MAJOR SITE DEVELOPMENT PLAN
7-ELEVEN - STORE #42975

SITE #1057022
BRADLEY ROAD AND LEGACY DRIVE

UTILITY PLAN

C4.1

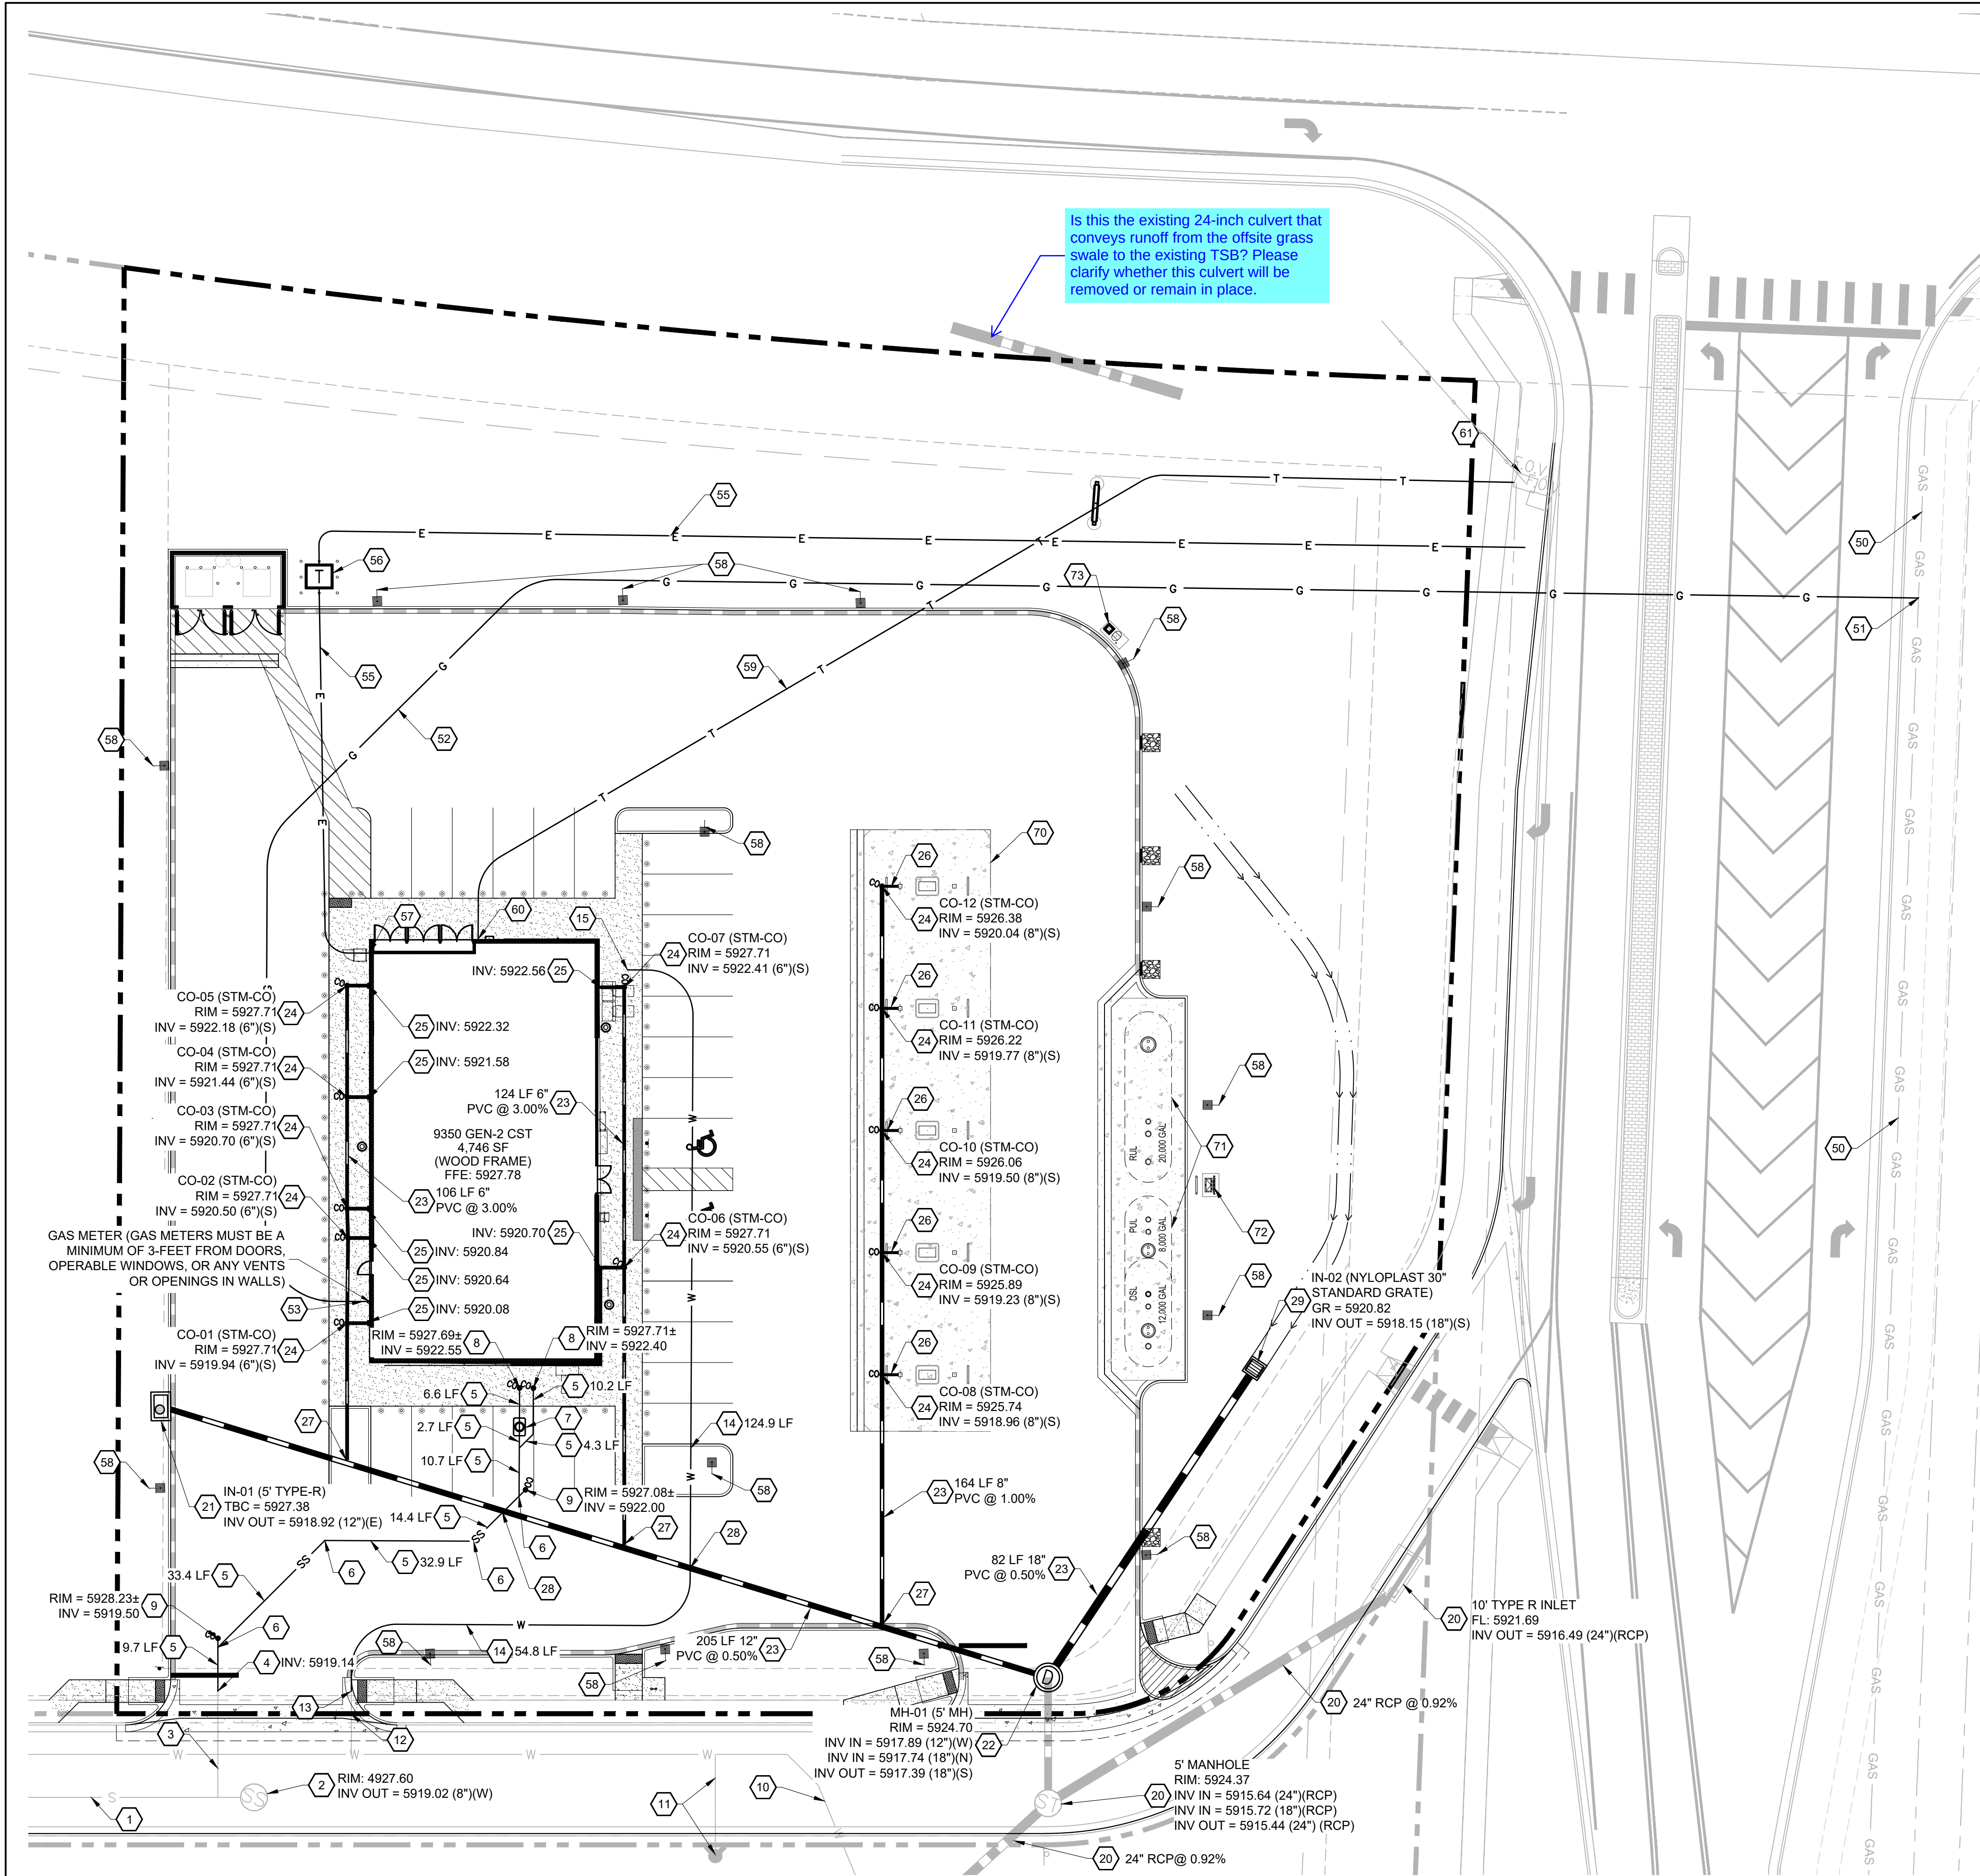
Is this the existing 24-inch culvert that conveys runoff from the offsite grass swale to the existing TSB? Please clarify whether this culvert will be removed or remain in place.
